## LCLS Undulator Quadrupole Magnet Design Changes After Inspecting And Testing The First Article Magnets

August 1, 2007

Below is a list of changes requested after testing the first article magnets:

**Figure 2: Magnet alignment of top and bottom.**

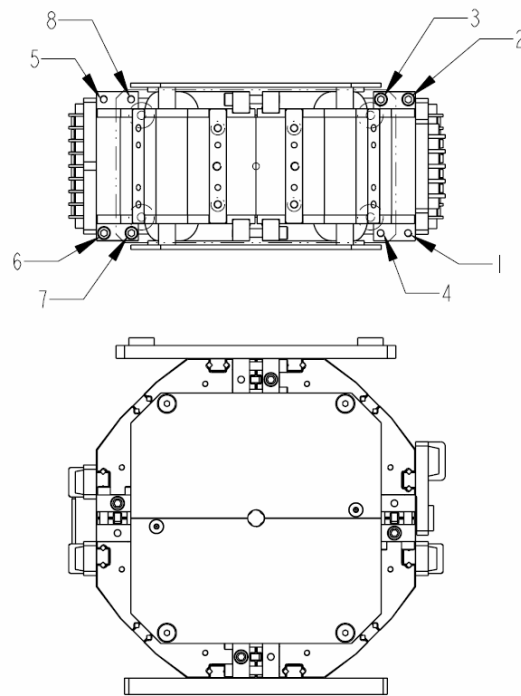
9. It was noticed during the split magnet test that one of the screws was not torqued. They were hand tight. Please use torque procedure (see attached procedure).

1. Hand tighten all screws.
2. Apply G-10 blocks with C-clamps to align top and bottom halves (see Figure 2).
3. Torque all screws to 2-3 ft-lbs in the following sequence: 1, 2, 3, 4, 5, 6, 7, and 8. See Figure 3 for screw identification.
4. Remove the C-clamps and G-10 blocks.
5. Torque all screws to 4-5 ft-lbs in the following sequence: 5, 6, 7, 8, 1, 2, 3, and 4.
6. Torque all screws to 7 ft-lbs in the following sequence: 1, 2, 3, 4, 5, 6, 7, and 8.
